A.M. Design Ltd.

Diakhali, Beron, Jamgara, Ashulia, Bangladesh

3 May 2014

Observations

Cracking in East facade

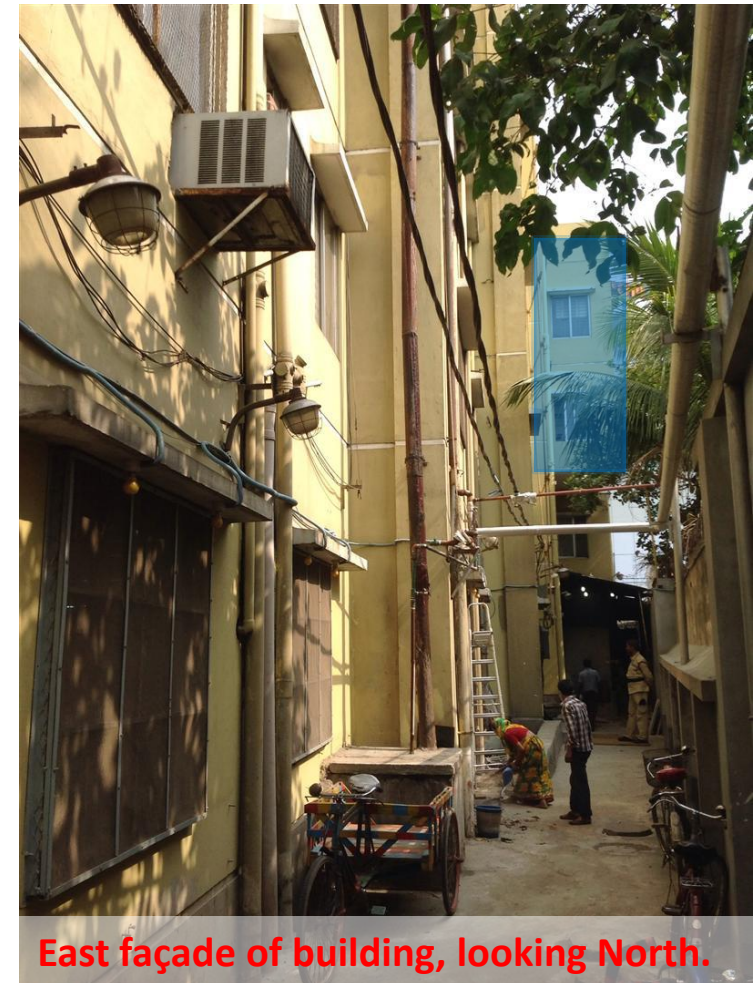
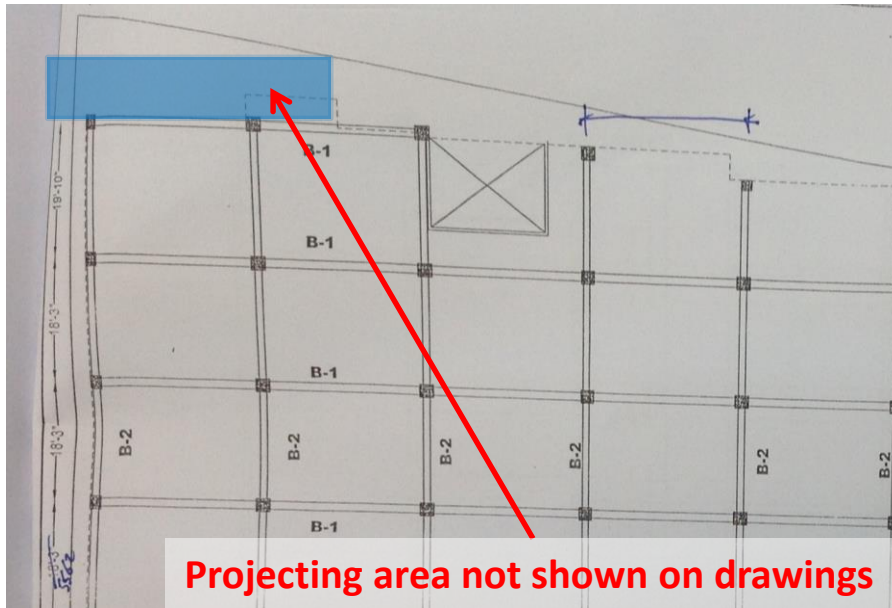
East bay GL 6-7 does not have a downstand beam at the perimeter to support masonry infill walls. Deflection of slab evident by cracking observed on east façade.

No downstand beam provided

No stiffening edge beam to assumed one way spanning slab

5	No stiffening edge beam to assumed one way spanning slab GL 6/7 parallel to GL G	Building Engineer to monitor façade cracking due to unstiffened slab edge and restrict floor use with loading plans as defined in item 1	6-months

Discrepancies between structural drawings and as built structure

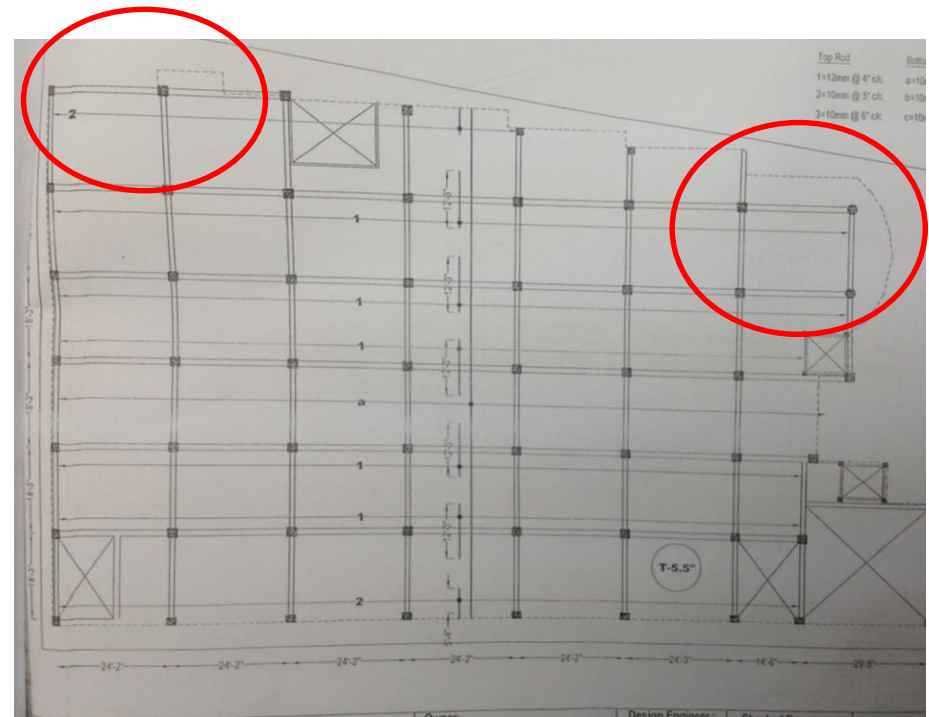
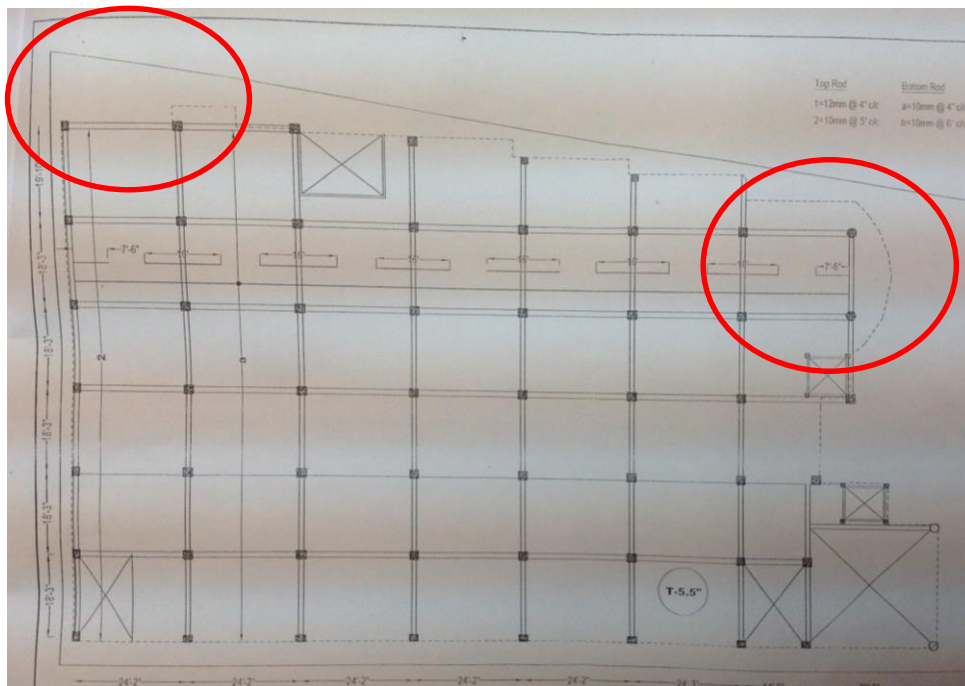
Structural drawings do not provide details for projecting area in North East corner of building. Architectural and permit drawings do show this area.

Incomplete reinforcement structural drawings and no details for cantilever slabs to Northeast or South of building.

Item No.	Observation	Recommended Action Plan	Recommended Timeline
6	Discrepancies between structural drawings and as built structure	As built structural drawings to be generated/updated for all buildings on factory complex. As built drawings to account for structural framing as observed on site.	6-months
7	Discrepancies between structural drawings and as built structure	As built drawings to be revised, as necessary, as future modifications are made to the building. Any strengthening works, as required, to be included on the as built drawings.	6-months
8	Minor hairline cracks observed in structural elements	Building Engineer to identify areas of structural cracking throughout building.	6-months
9	Minor hairline cracks observed in structural elements	Building Engineer to continue to monitor size, length and location of structural cracking throughout.	6-months
10	Future vertical extension	Prior to future extension commencing, Building Engineer to verify column capacities exceed future design loading, accounting for actual loading throughout existing building. Loading plans to be updated as required.	6-months

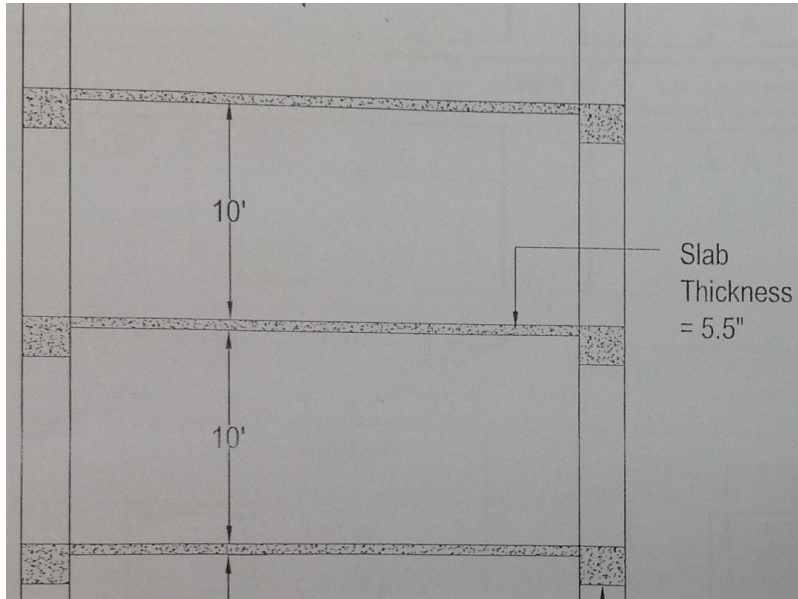
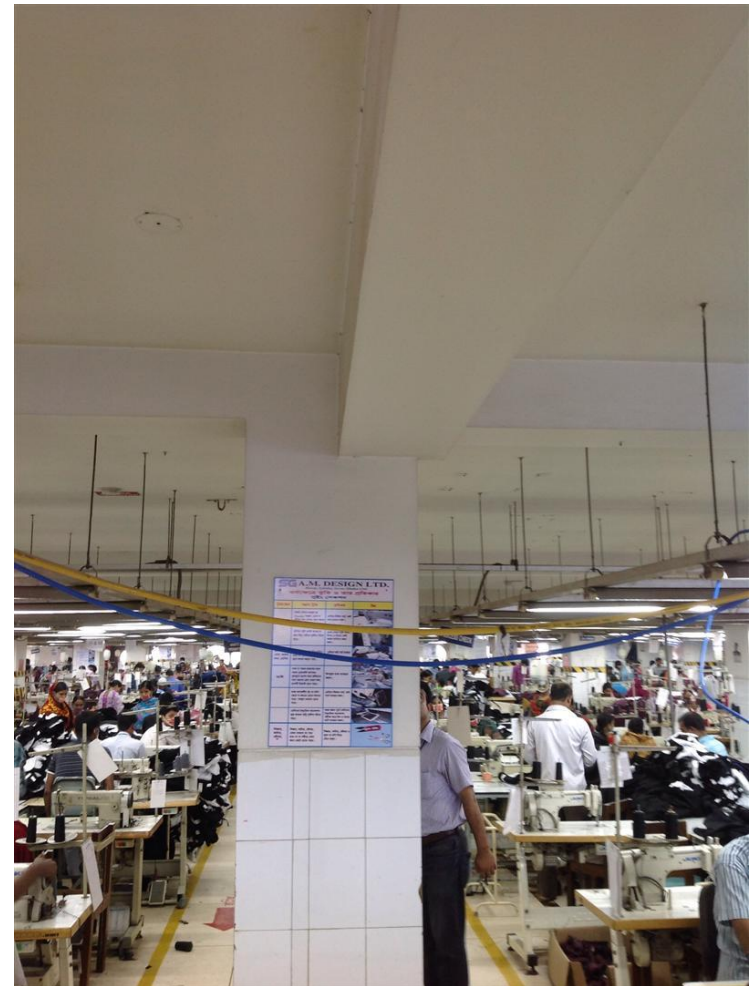
5.5" thick slab indicated on drawings (140mm). Slab thickness observed on site varied between approximately 140mm and 170mm.

Beam frames into column eccentrically in a number of locations.

Minor hairline cracks observed in structural elements

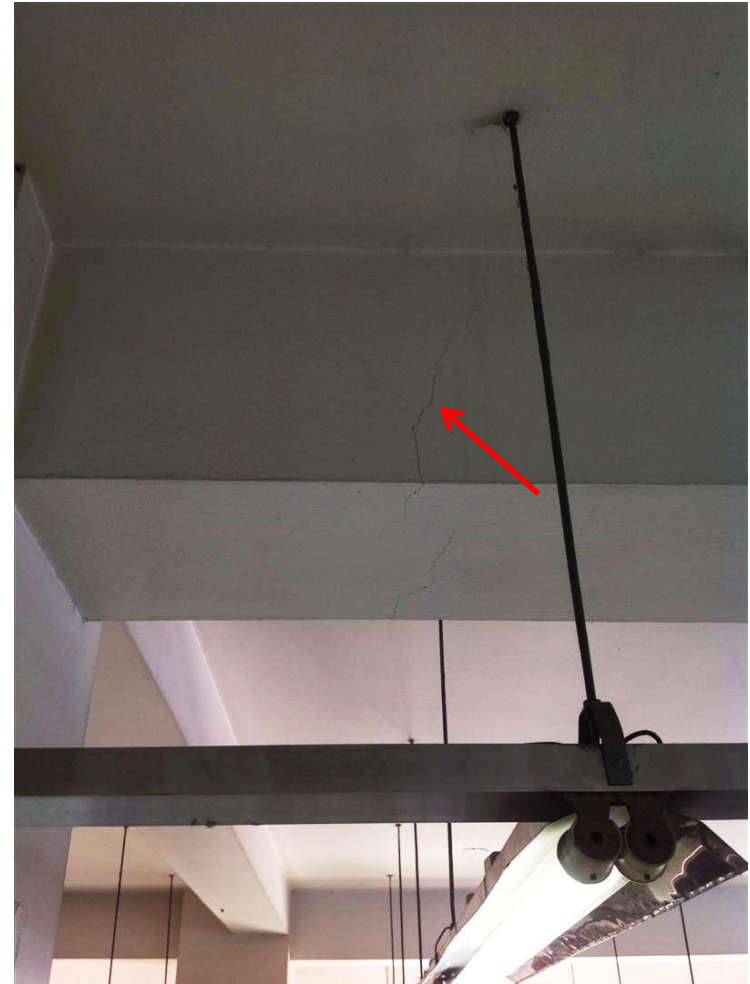
Hairline cracks observed at soffit of roof slab. Evidence of dampness in at location of crack.

Vertical cracking observed in sides and soffits of a number of beams throughout the building.

Future vertical extension

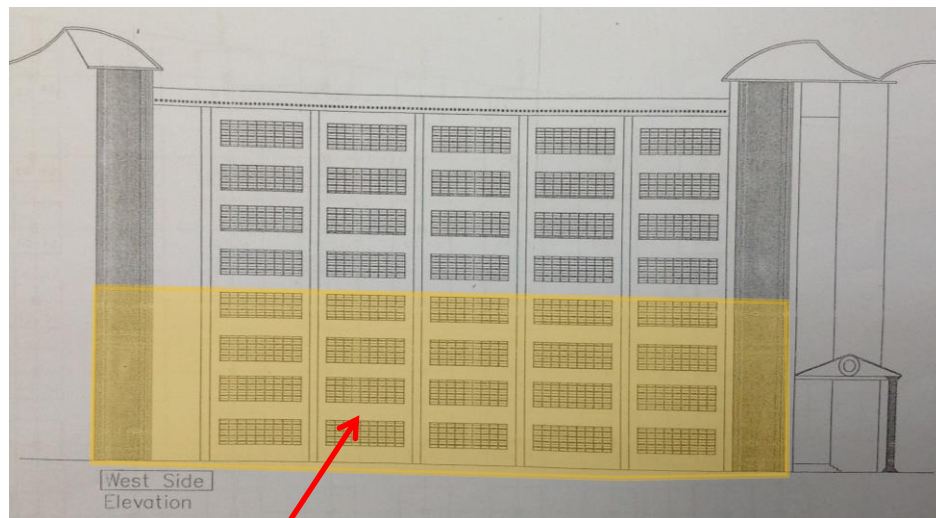
Factory Management indicate that they intend to extend the structure vertically in the future. Four additional storeys are planned. Column reinforcement continues past slab level at existing roof.

Architectural drawings reviewed show complete eight storey building. Permit drawings do not indicate the number of storeys that have been approved.
